# UNITED STATES PATENT AND TRADEMARK OFFICE

APPLICATION NO.	FILING DATE	FIRST NAMED INVENTOR	ATTORNEY DOCKET NO.	CONFIRMATION NO.
09/686,468	10/11/2000	Nathan A. Torgerson	11738.00001	3373
7590	03/02/2004		EXAMINER	
Scott A Burow Banner & Witcoff Ltd 10 S Wacker Drive Chicago, IL 60606			MENDEZ, MANUEL A	
		ART UNIT	PAPER NUMBER	
		3763	4	
DATE MAILED: 03/02/2004

<b>Office Action Summary</b>	<b>Application No.</b>	<b>Applicant(s)</b>
	09/686,468	TORGERSON ET AL.
Examiner	Art Unit	
Manuel Mendez	3763

Claim 1 is rejected under 35 U.S.C. 103(a) as being unpatentable over Haller, et al., in view of Cannon.

FIG. 1

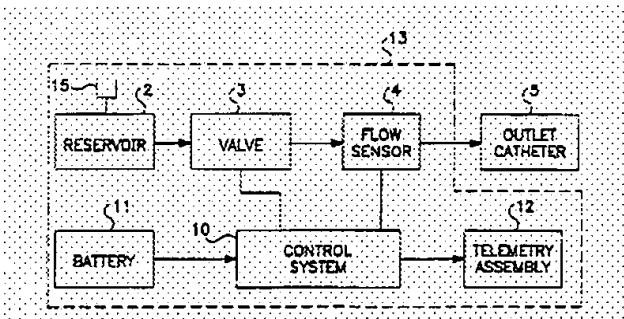
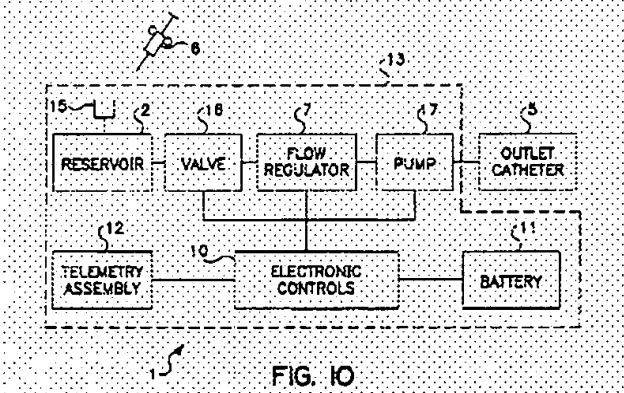
In figures 1 and 10, Haller, et al., shows an implantable apparatus having a fluid reservoir, a regulator assembly adjustable to a plurality of flow rate settings for

regulating flow, electromechanical control means for changing flow rates and means for receiving signals. The cited patent does not disclose the use of a radio frequency signals. However, such use is conventional as evidenced by the teachings of Cannon.

**In column 1, lines 22-24,** Cannon specifically asserts that the use of radio frequency signals in combination with implantable pumps is well known in the art. Accordingly, for a person of ordinary skill in the art, the use of the radio frequency spectrum in the design of the telemetry devices in implantable pumps would have been considered an obvious design choice.

Option Number I

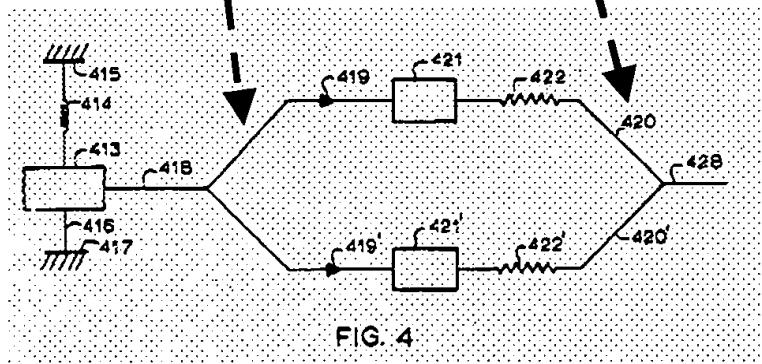
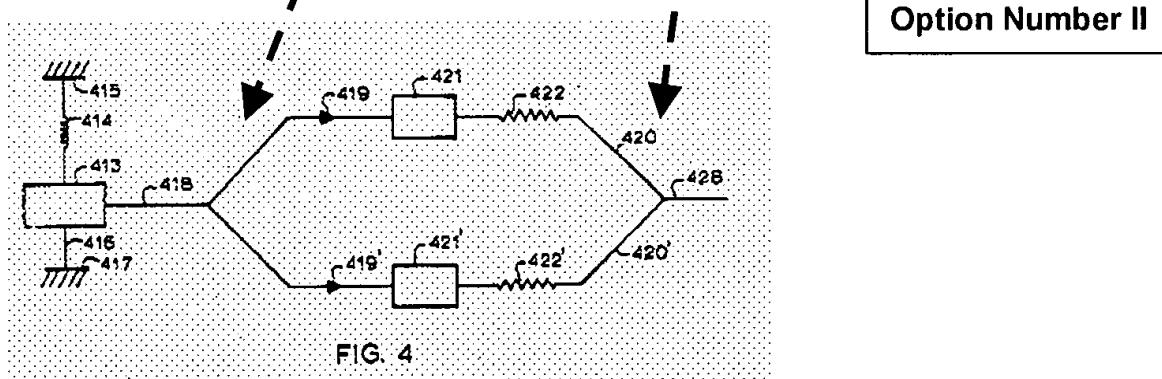
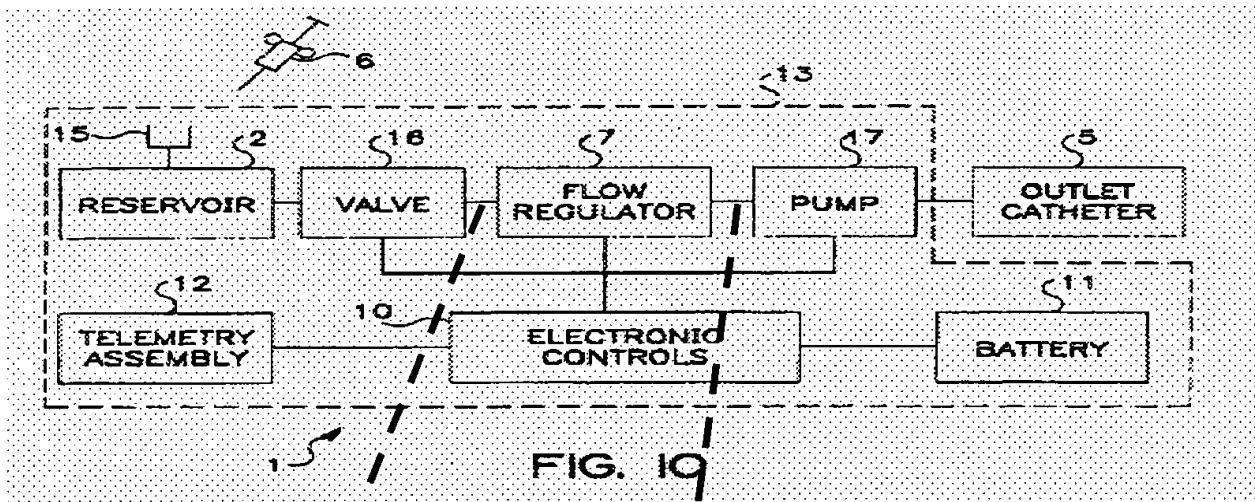
Haller, et al., does not disclose a plurality of flow restrictors operatively coupled to the valve for providing a plurality of flow rates. However, in figure 4, Cannon shows an embodiment using multiple flow restrictors to modify flow rate. Furthermore, in column 5, lines 47-56, Cannon discloses that flow varies according to the resistance (flow restrictor) selected for the system resulting in multiple flow rates.

Accordingly, it would have been obvious for a person of ordinary skill in the art to modify Haller, et al., by modifying figures 1 or 10 above with multiple fluid paths having

different flow rates as taught by Cannon since the enhancement would have expanded the infusion capabilities of the implantable pump. Conclusively, such modification or enhancement would have been considered an obvious design choice.
